ED-MONITOR-133C

PCN

by EDA Technology Co., Ltd

1 Product Change Notice 1

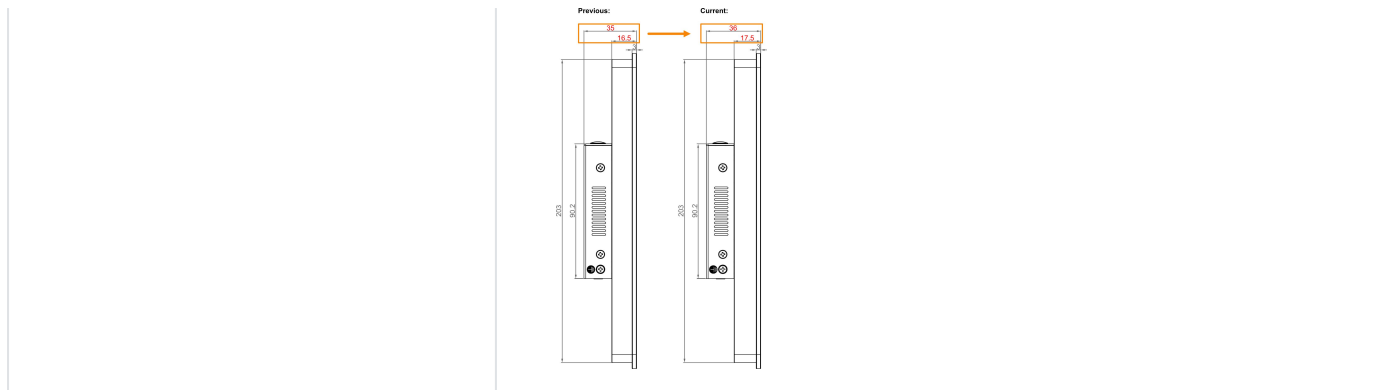
Changes	Results
LCD bezel thickness increased by 1mm	We have optimized the LCD bezel structure to provide additional clearance for internal cable routing. - LCD bezel thickness: adjusted from 16.5mm to 17.5mm. - Total product thickness: correspondingly adjusted from 35mm to 36mm.
